Comments on a Substantive Application under section 53 of the Fast-track Approvals Act 2024: Landscape and Visual Assessment

Fast-track project name	Mt Welcome, Pukerua Bay, Porirua
Fast-track application no.	FTAA-2603-1181
PCC reference	RCO26120

Technical area	Landscape and Visual Assessment
Date	30 July 2026
Author	Andrew Gray - Landscape Architect (BLA, B. Hort)
Statement of expertise	I am employed as a Landscape Architect in the Infrastructure Group, Parks Team of the Porirua City Council. I hold the degree of Bachelor of Landscape Architecture (Honours) from Lincoln University, Canterbury and a Bachelor of Horticulture from Massey University, Palmerston North. I am a Registered Member of the New Zealand Institute of Landscape Architects and past Executive committee member of the Institute. I have over 30 years work experience as a Landscape Architect in NZ.
Code of conduct	I confirm that I have read and agree to comply with the Code of Conduct for Expert Witnesses contained in the Environment Court Practice Note 2023. This technical memorandum has been prepared in accordance with that Code. Unless I state otherwise, the opinions I express are within my area of expertise, and

Figure 1: Proposed works within SH59 corridor.

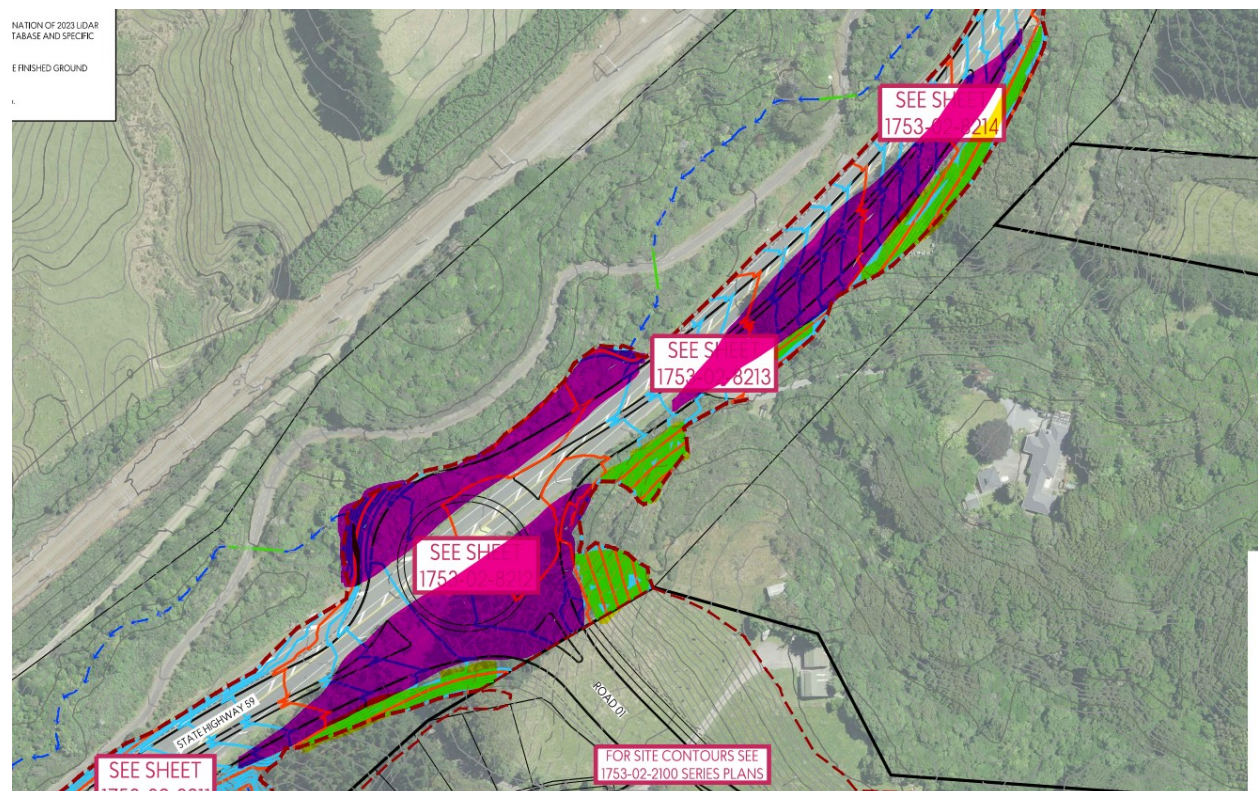
The key aspect that has been overlooked by the submitted LVEA is the impact of the earthworks required for the formation of the entrance into the development on SH59. The proposed roundabout results in the removal and loss of existing native vegetation and tall cut faces orientated towards the State Highway. The cut faces and loss of vegetation are shown in **Figure 1** below.

This is a significant omission as, while it is outside the applicant's ownership, the earthworks are arising because of the development and are included within the Fast Track resource consent application.

Purple highlights = loss of vegetation and Green highlights = cut faces

This is true for the majority of SH59, except for the entrance where the existing vegetation is being removed and reasonably large cut faces (up to 12 metres high) are being formed which open up views into the site.

Figure 2: LEP plan showing that the planting proposals do not include the SH59 road reserve (highlight added)

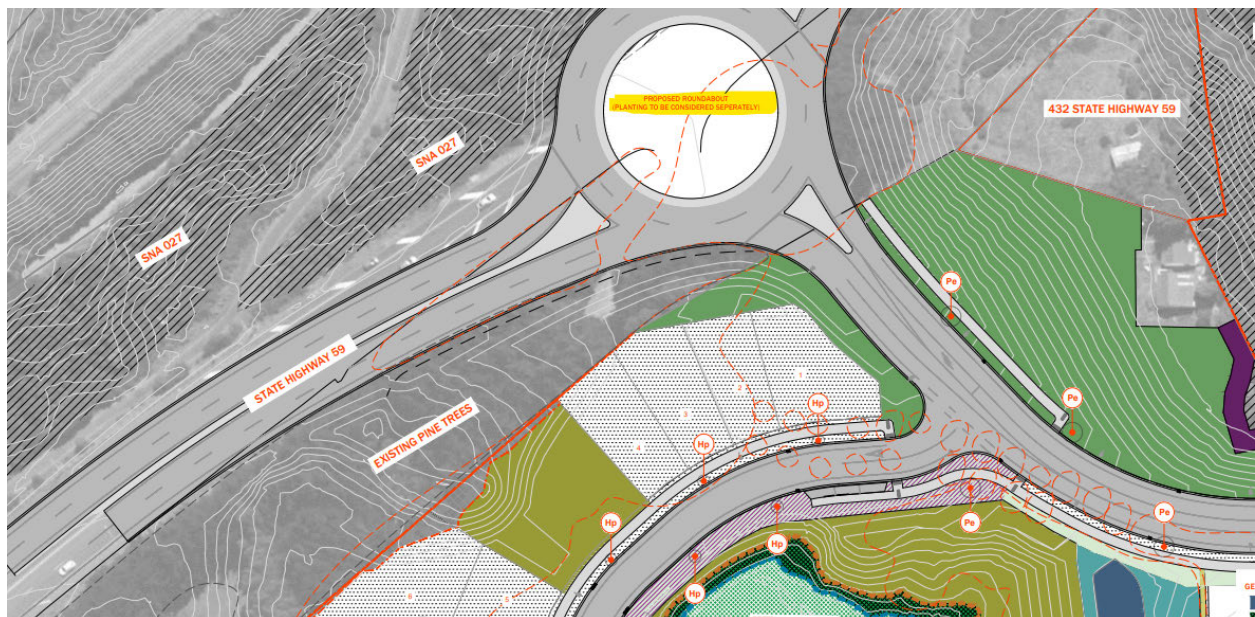
The other aspect that is of concern is that the mitigation planting within the SH59 corridor to visually remedy the cut faces and vegetation loss is not defined. Neither the current Masterplan and Landscape Urban Design Strategy document attached to the application at Appendix 22, nor the Landscape and Ecology Plans address the SH59 land. The only reference to this part of the proposed development in terms of planting and landscape effects mitigation is on the plan below which has a label which states "*proposed roundabout planting to be considered separately*".

Given the potential visual impacts on users of a State Highway at relatively close proximity and the policy direction in DEV-NG-P2-2, I consider that this area is worthy to be a viewpoint considered by the application in the LVEA.

The Northern Growth Development Area anticipated an entrance in this area as shown on the Structure Plan contained in *DEV-NG-Figure 1 Northern Growth Development Area Structure Plan*. However, I consider that the lack of mitigation plans for the SH59 road reserve is not meeting the requirements of policy DEV-NG-P2 identified above.

I consider that additional consent conditions should be provided to address the visual mitigation of the entrance to the site and the associated cut batters within the State Highway 59 (SH59) road corridor. Particular attention should be given to remedying any loss of native vegetation around the Taupo Stream on the north-west side of SH59 by the proposed entrance intersection and any resulting cut faces, as well as remedying the tall cut batters faces created on the south-east side of SH59 for forming the entrance into Mount Welcome and maintaining the character and amenity values of this area in the General Rural Zone. Any proposed landscaping will need to be developed in conjunction with NZTA as the road controlling authority.
